ADDENDUM NO. 2

LOWELL HIGH SCHOOL IMPROVEMENTS 2025
Lowell, IN 46356

ADDENDUM TWO

Addendum Two (AD.02) to the drawings and specifications prepared by Gibraltar Design for **Lowell High School Improvements 2025** for Tri-Creek School Corporation, Lowell, Indiana.

A-401

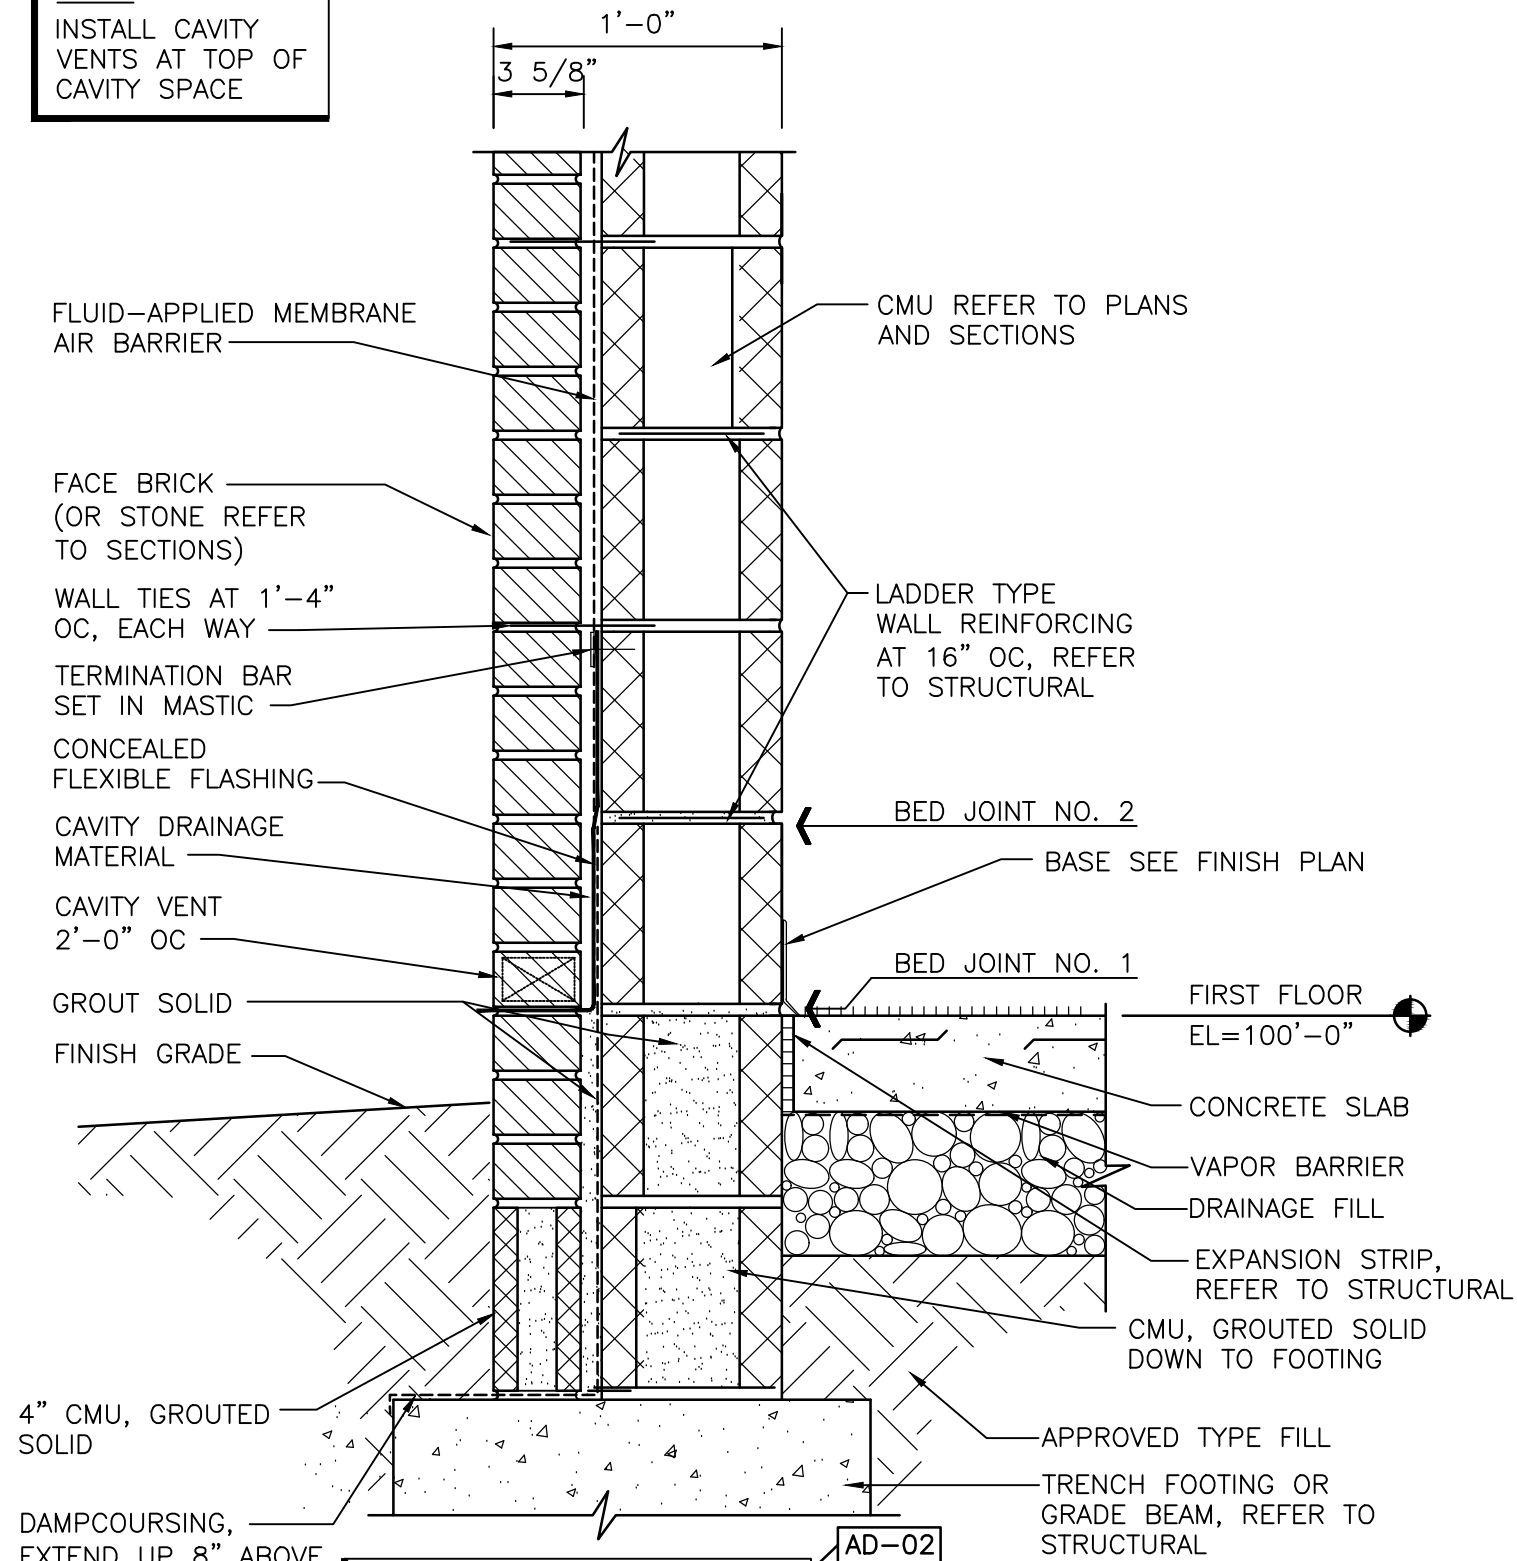
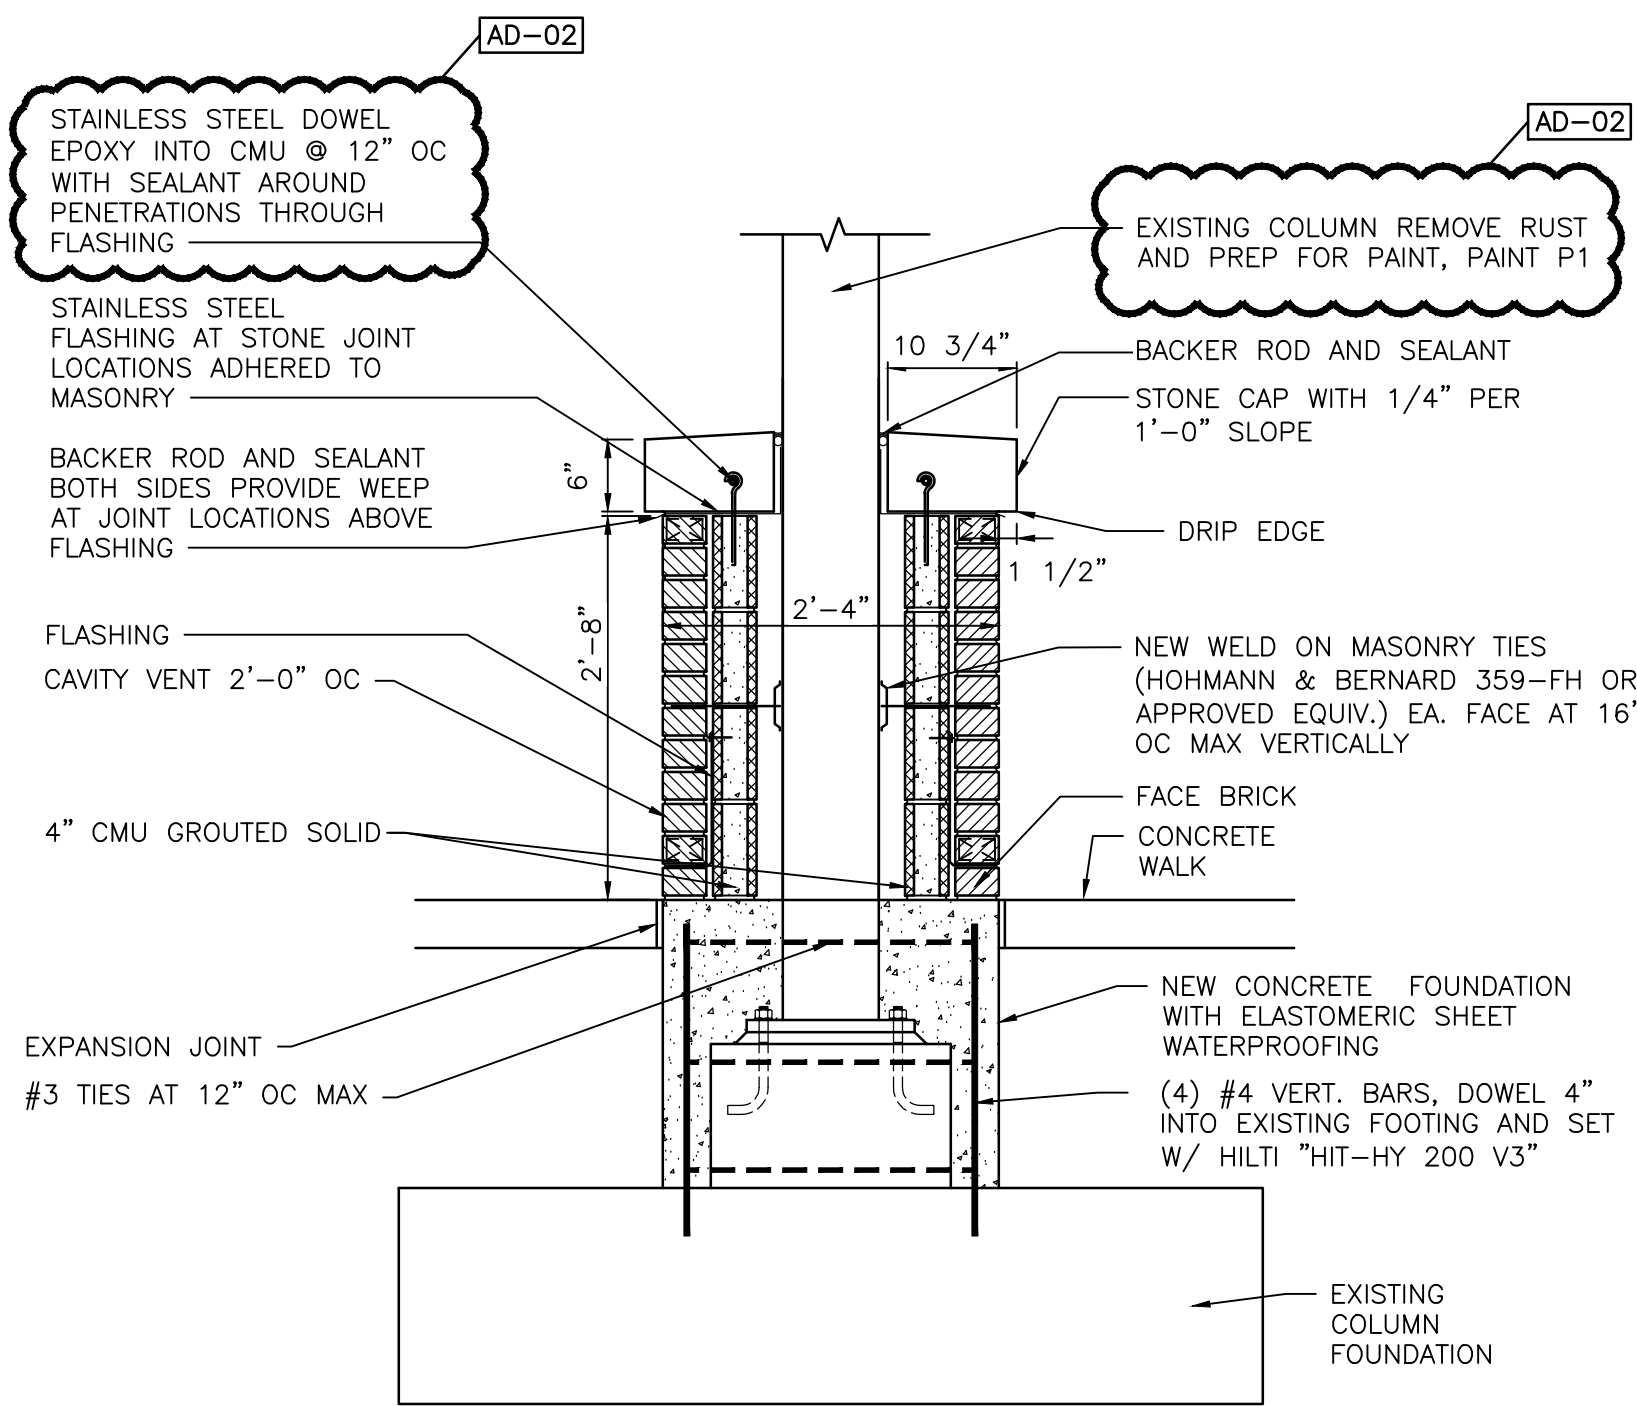
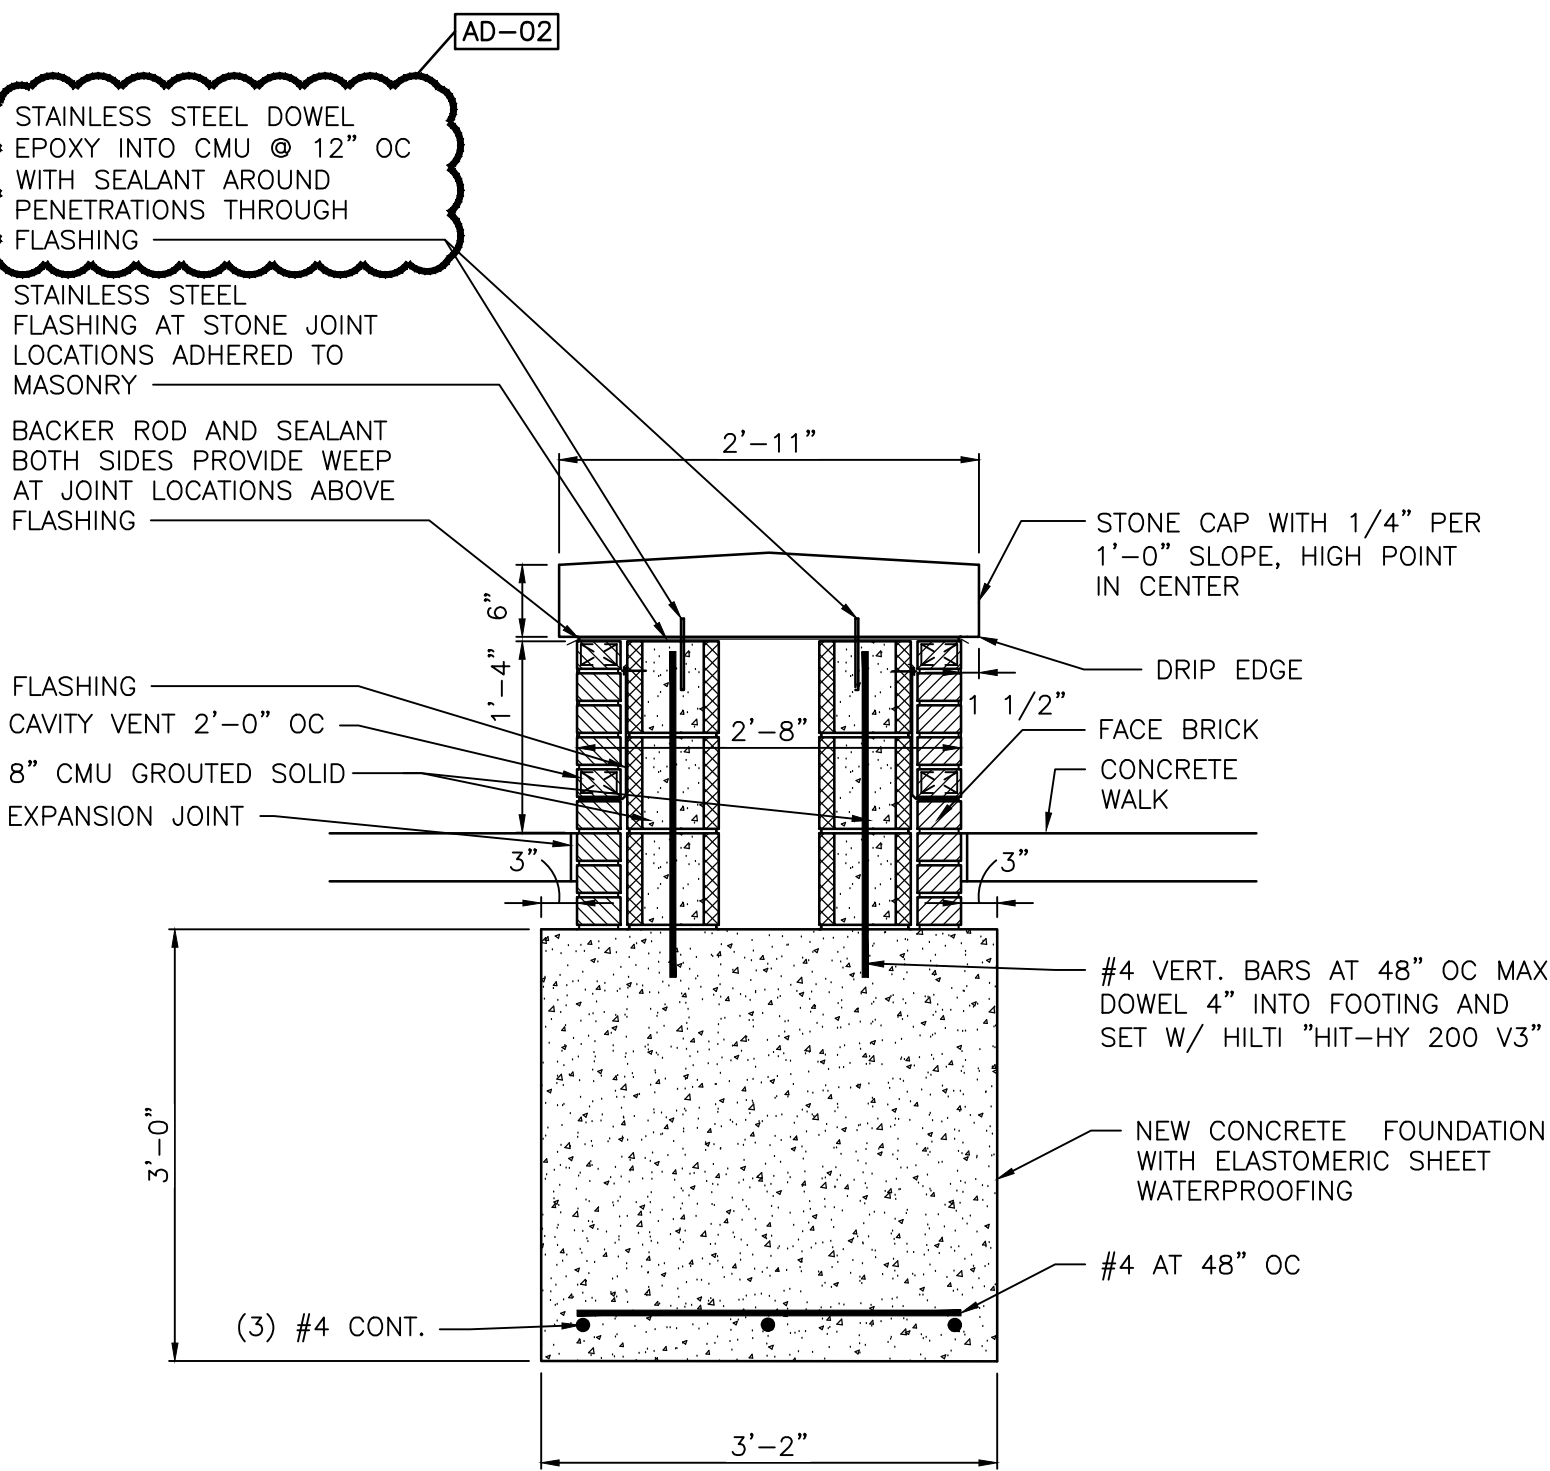
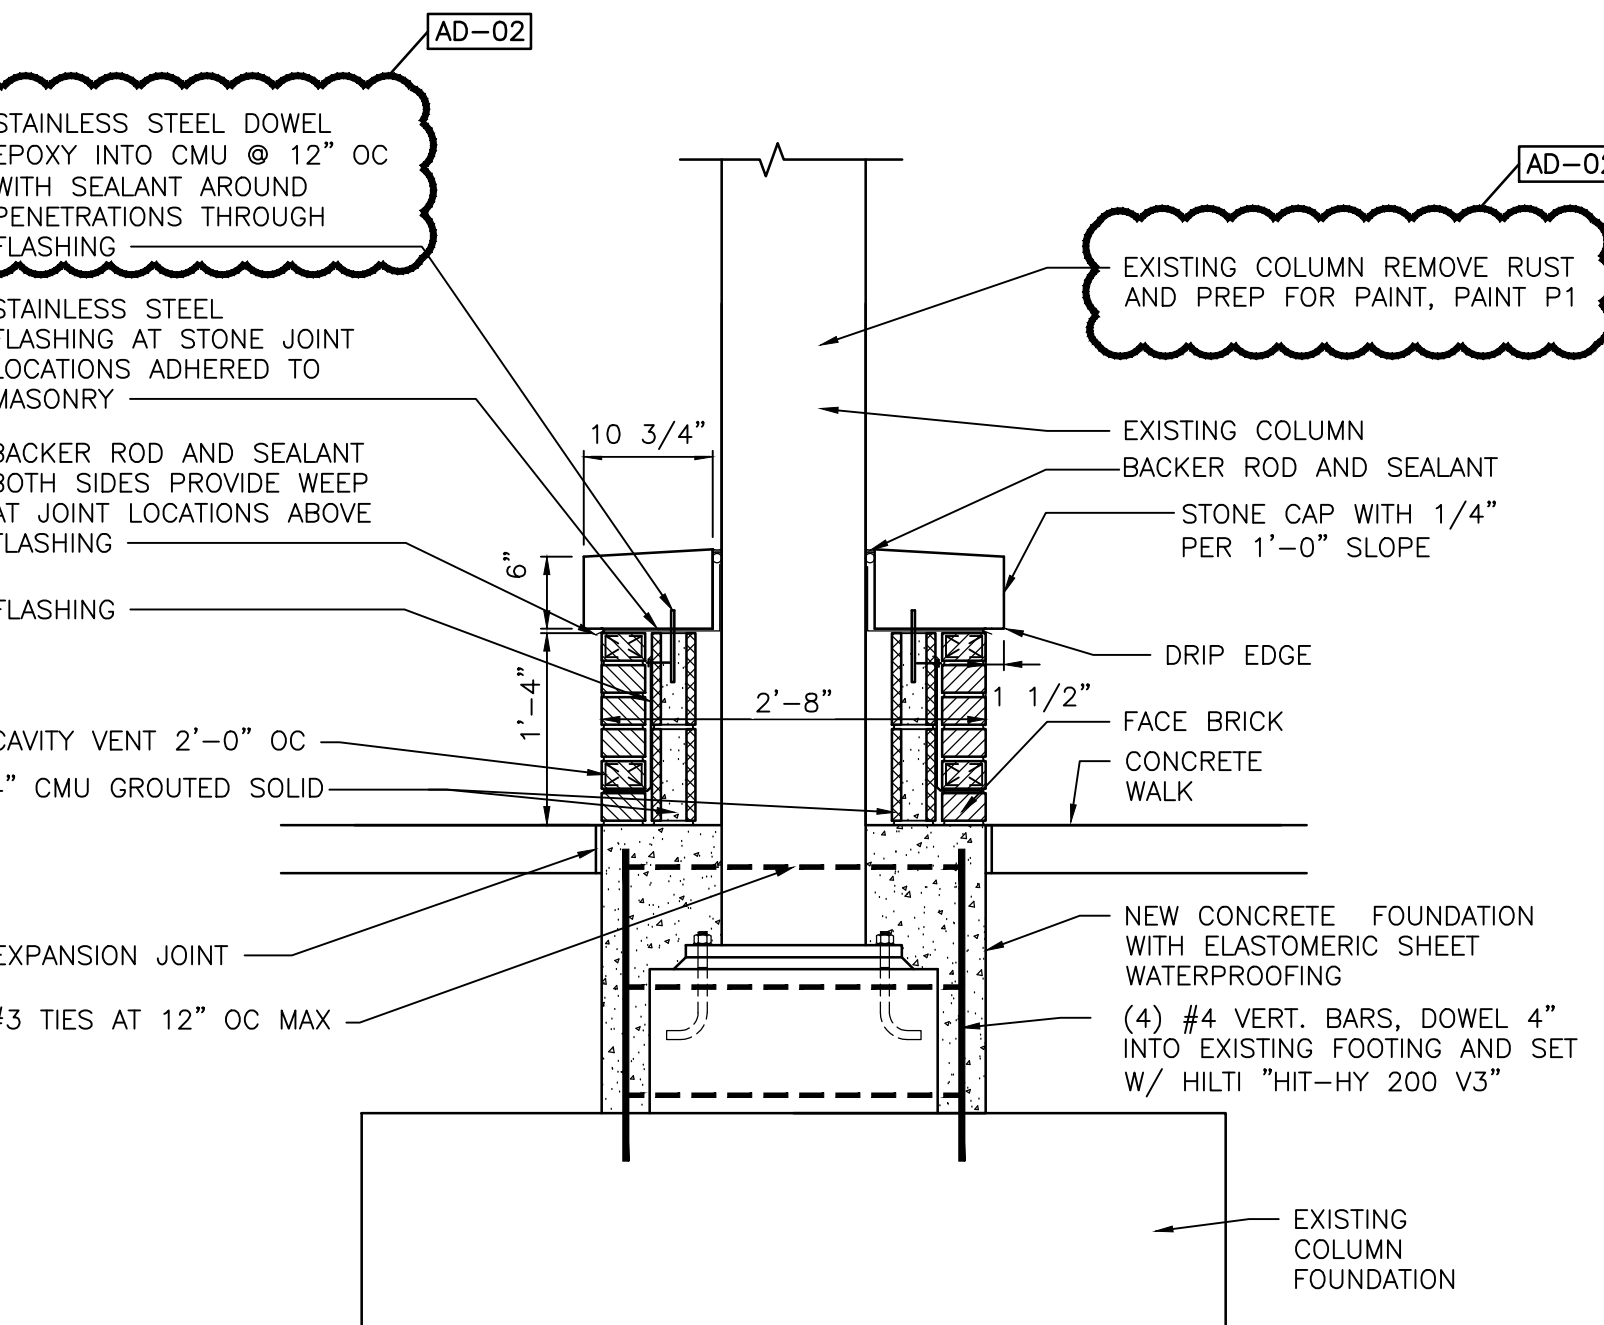
5. Sheet A-401

Revise Details 1, 2, 3, and 4 per the attached drawing.
